# The Light company

ST-HL-AE-1464

South Texas Project  
Units 1 and 2  
Docket Nos. STN 50-498, STN 50-499  
Responses to DSER/FSAR Items  
Regarding Chapter 7A, Item II.F.2

<u>Attachment</u>	<u>Item No.*</u>	<u>Subject</u>
1	D 4.4-4 D 4.4-5	Revision to Chapter 7A, Item II.F.2 to 1) provide item-by-item evaluation of Core Exit Thermocouple System against Attachment 1 of II.F.2 of NUREG 0737 and 2) address aspects of ICC system which deviate from NUREG 0737.

Figure 7A.11.F.2-1

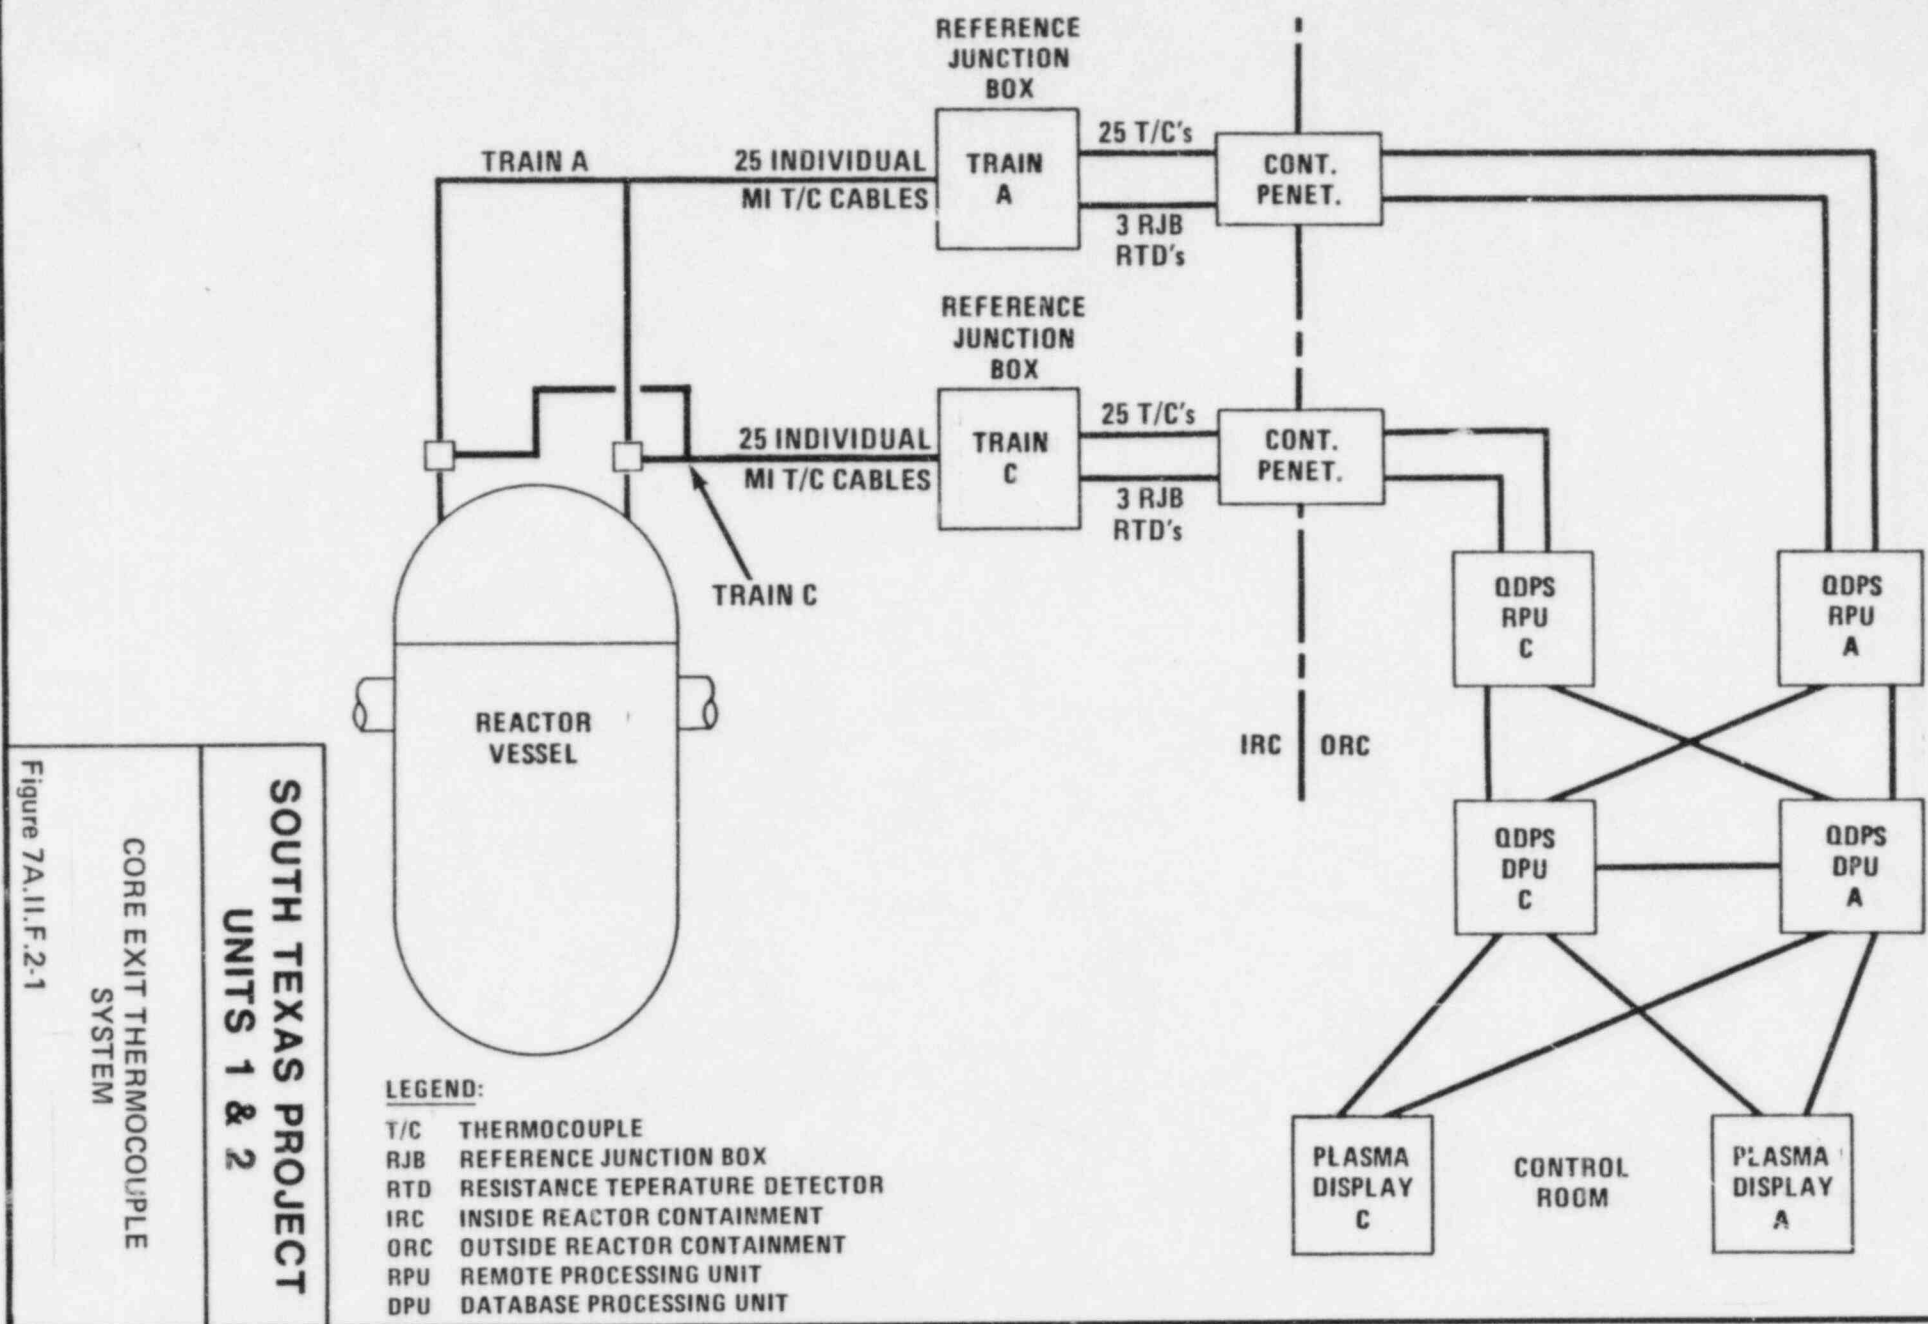
The core exit thermocouple monitoring system consists of two redundant trains that monitor all 50 of the South Texas Project chromel-alumel core exit thermocouples (25 on each train). A block diagram of the system is shown in Figure 7A.II.F.2-1. The core exit thermocouples are mounted at the top of the core support plate.

The equipment used for core exit temperature monitoring (shown in Figure 7A.II.F.2-1) has been designed to meet the intent of IEEE 279-1971 as discussed in section 7.5.6.2.

Figure 7A.II.F.2-2

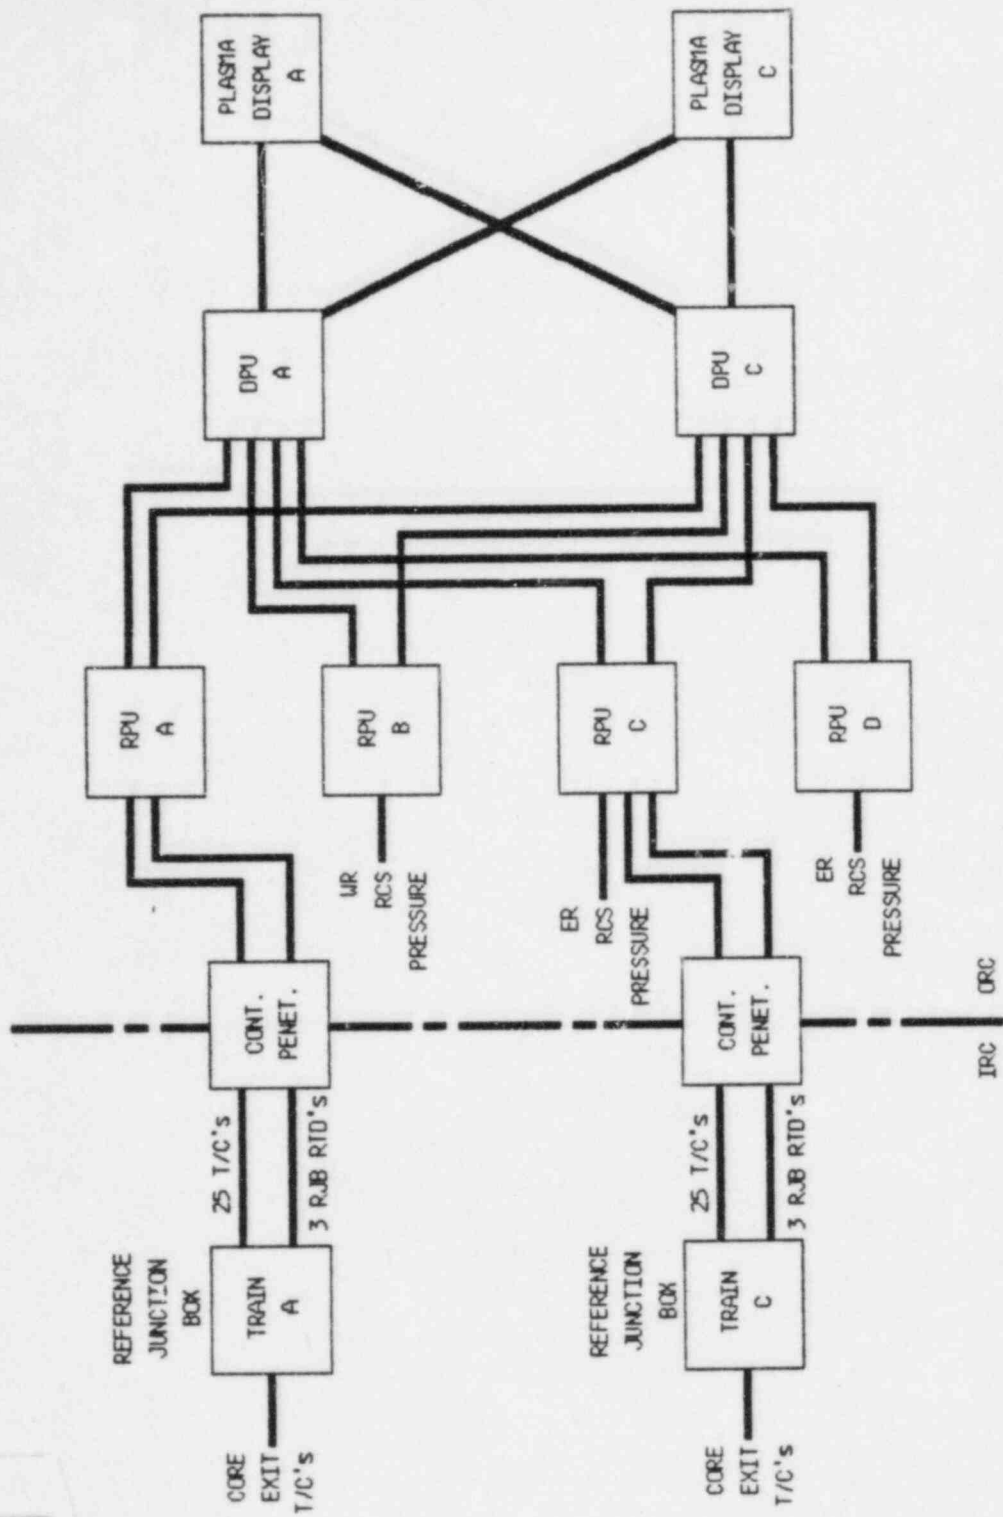
A block diagram of the core subcooling margin monitor is shown in Figure 7A.II.F.2-2. One channel of RCS pressure (wide range/extended range) is input into each of RPU B, C, and D. Also 25 uncompensated thermocouple channels and the corresponding three reference junction box RTD signals are input into each of RPU A and C. The outputs of each of the RPU's are routed to each DPU. The core subcooling margin is then calculated using the wide range/extended range RCS pressure and compensated core exit thermocouple readings. The value of RCS pressure utilized in the calculation is the average of the valid pressure signals. The value of core subcooling margin is based upon the auctioneered high quadrant average temperature.

The equipment used for core subcooling margin monitoring (shown on Figure 7A.II.F.2-2) has been designed to meet the intent of IEEE 279-1971 as discussed in section 7.5.6.2.

Figure 7A.II. F.2-3

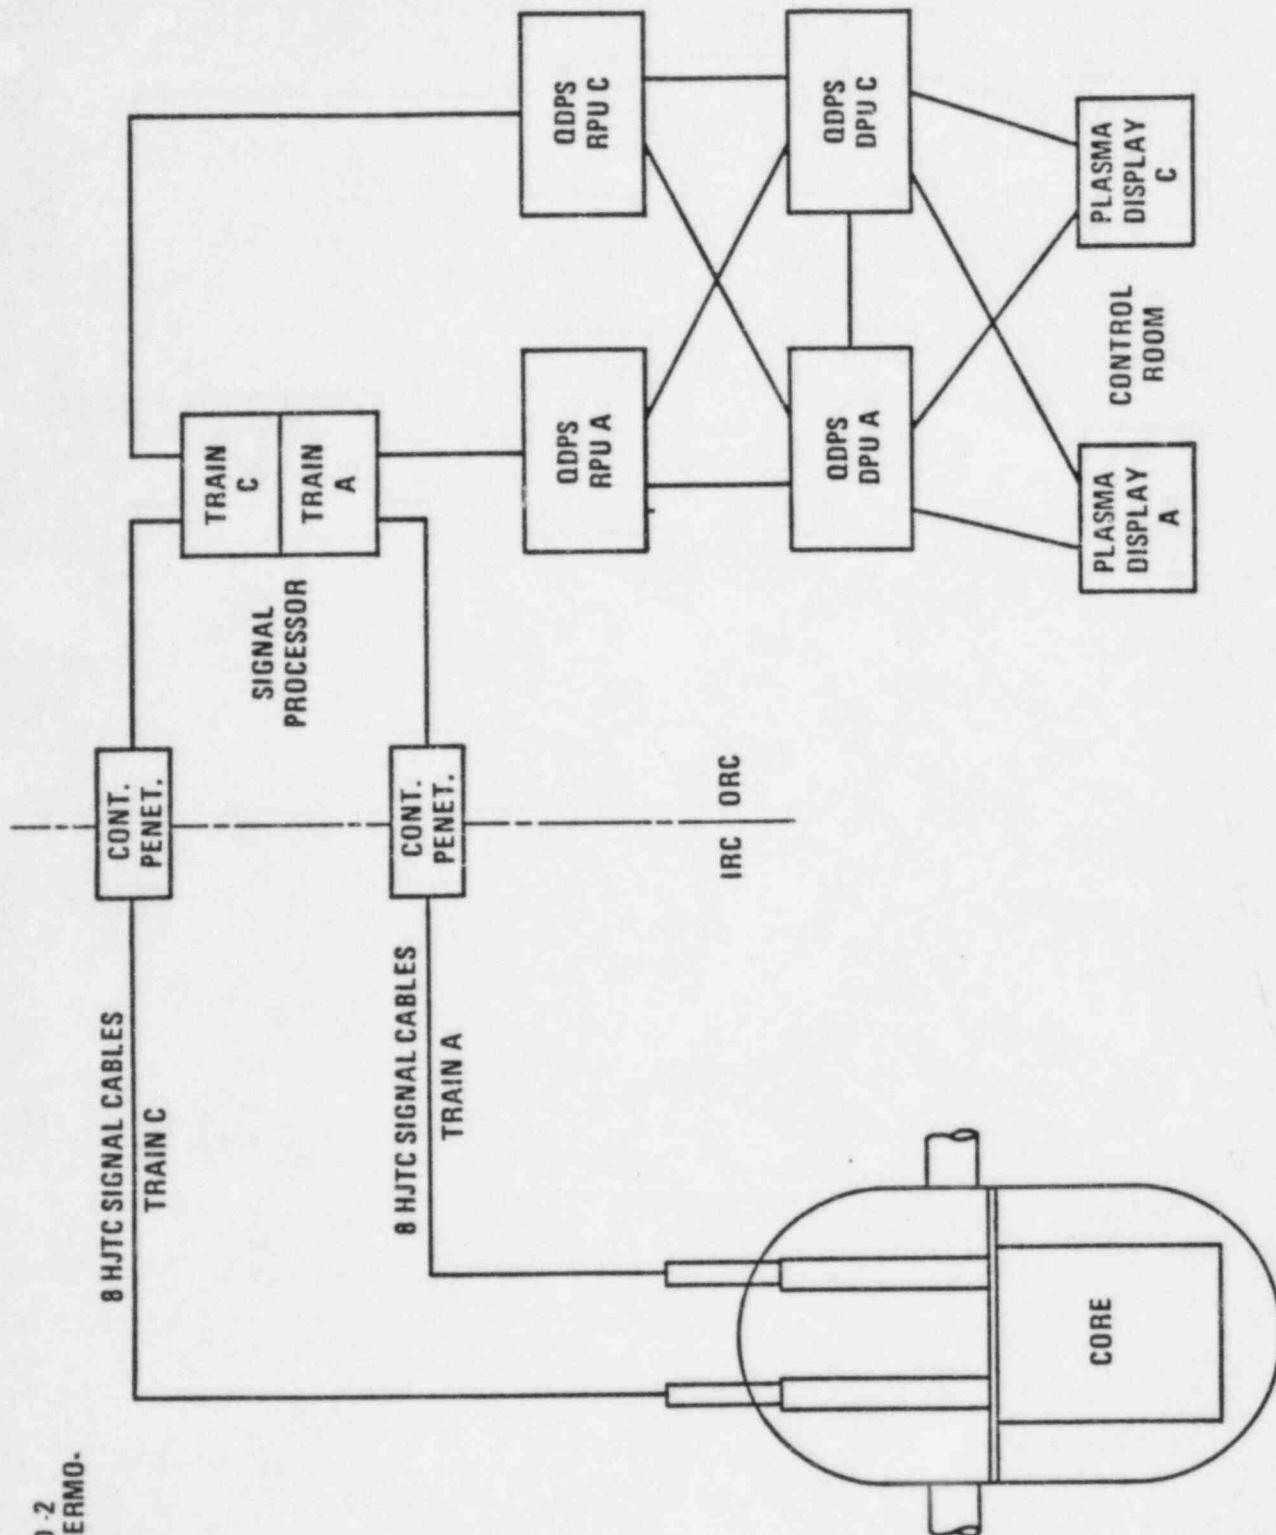
A block diagram of the reactor vessel water level system is shown in Figure 7A.II.F.2-3.

The equipment used for reactor vessel water level monitoring (shown on Figure 7A.II.F.2-3) has been designed to meet the intent of IEEE 279-1971 as discussed in section 7.5.6.2.
